Point Beach Nuclear Plant, Units 1 and 2  
Dockets 50-266 and 50-301  
Renewed License Nos. DPR-24 and DPR-27

License Amendment Request 277, Revision to Staff Augmentation Times in the  
Point Beach Nuclear Plant Emergency Plan

#### **LICENSE AMENDMENT REQUEST 277**

FIGURE 5-3  
TECHNICAL SUPPORT CENTER (TSC) AND OPERATIONS SUPPORT CENTER (OSC)

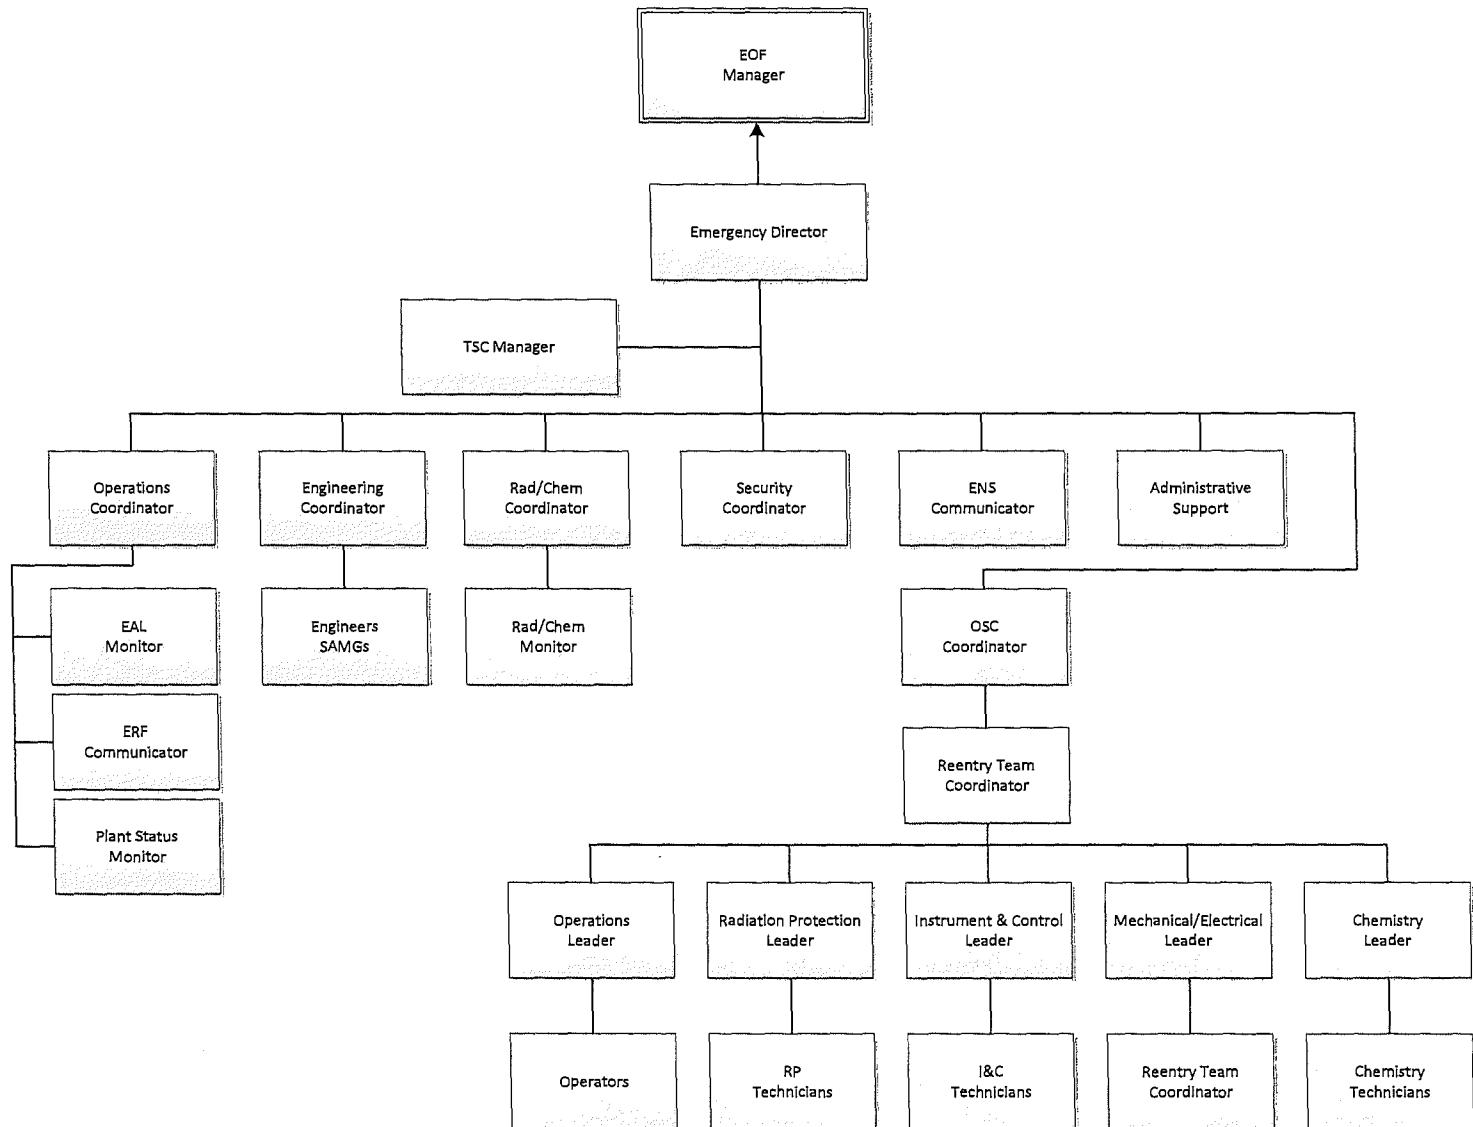
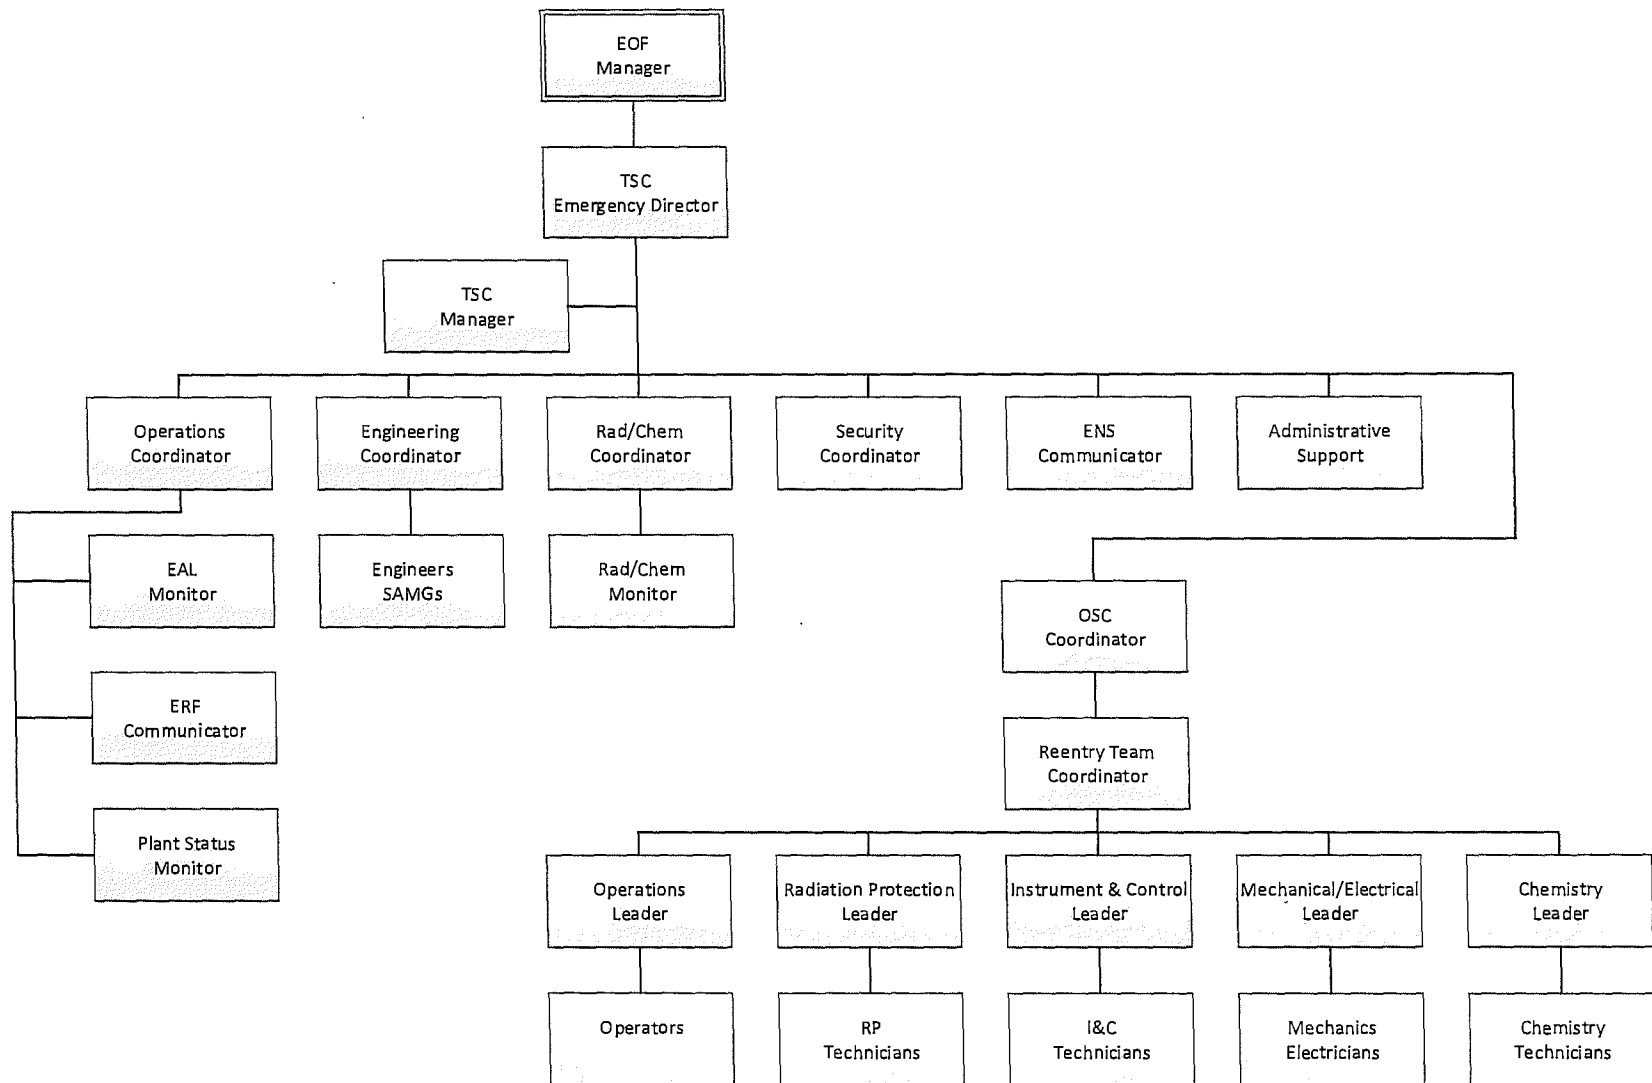
- o. EP 5.0, "Organizational Control of Emergencies," Figure 5-3, "Technical Support Center (TSC) and Operations Support Center (OSC)," has been revised to reflect the addition of the Emergency Director position and the EAL Monitor to the TSC organization.

FIGURE 5-4  
EMERGENCY OPERATIONS FACILITY (EOF) AND OFFSITE RADIATION PROTECTION FACILITY (OSRPF)

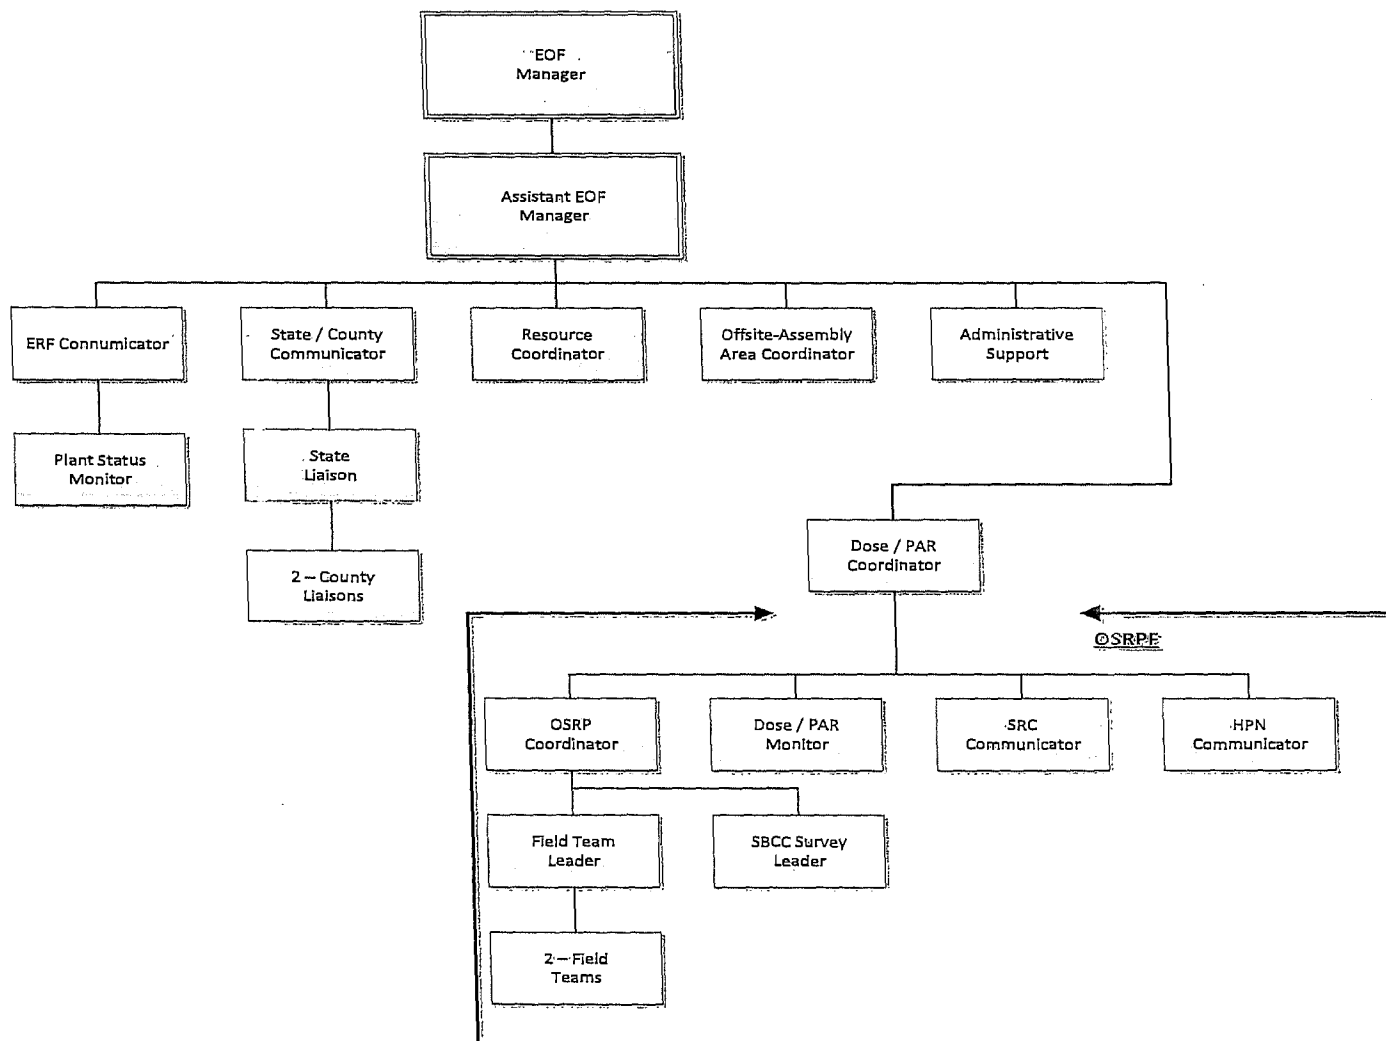
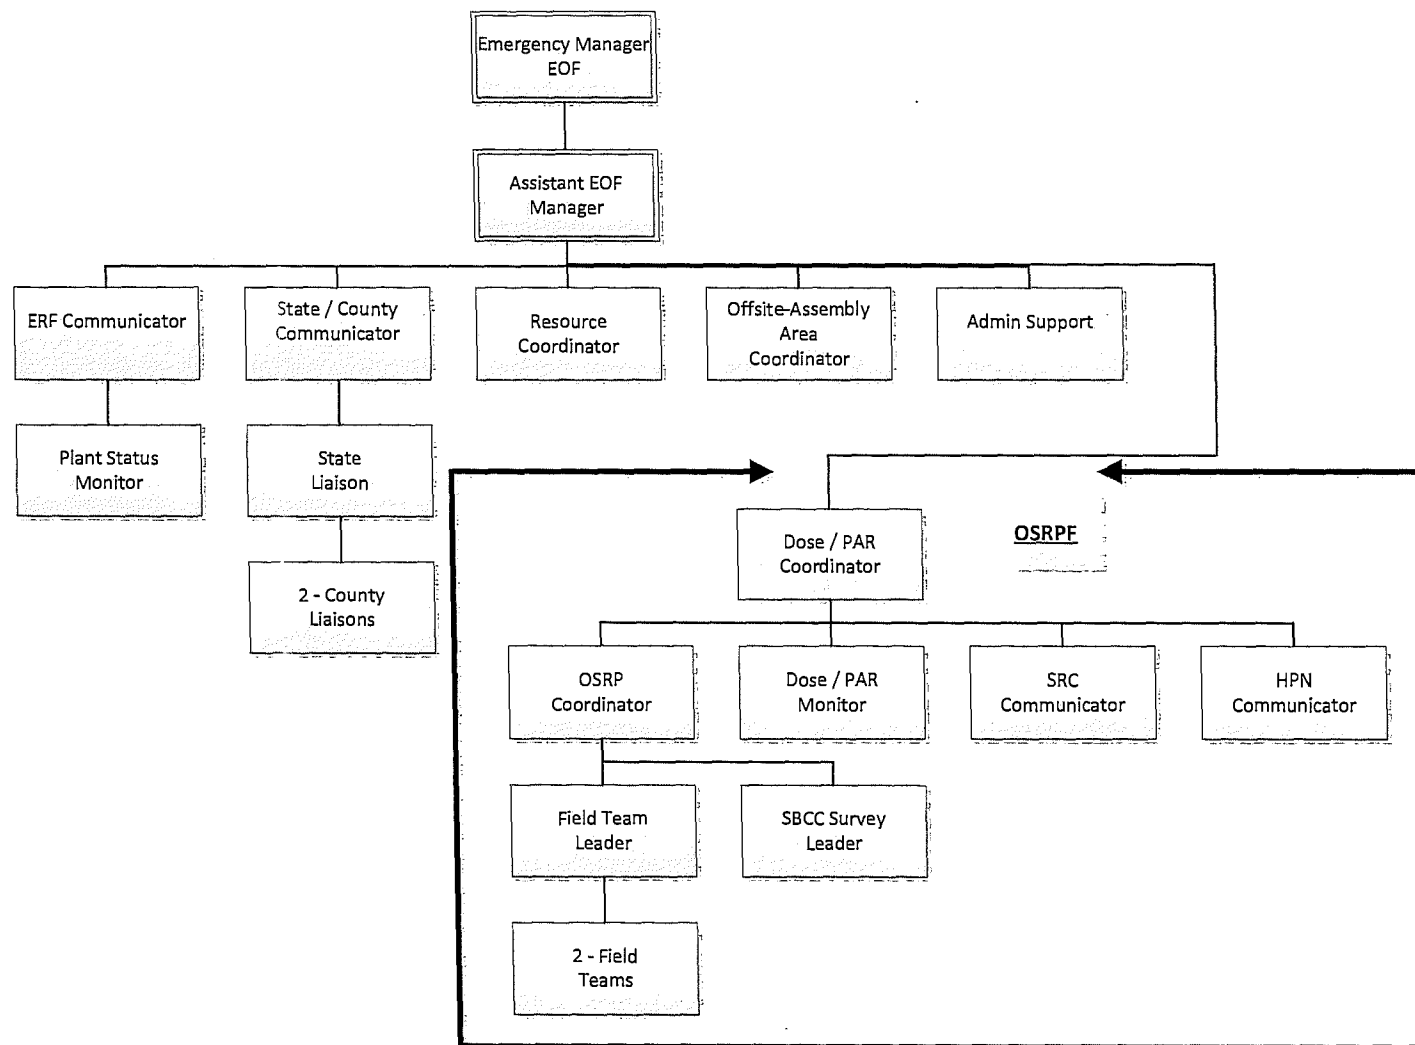
- p. EP 5.0, "Organizational Control of Emergencies," Figure 5-4, "Emergency Operations Facility (EOF) and Offsite Radiation Protection Facility (OSRPF)," has been revised to reflect:

- The title change from Emergency Director to Emergency Manager EOF
  - The addition of the Assistant EOF Manager position
  - Removal of the EAL Monitor position from the EOF in accordance with the change cited in Figure 5-3.
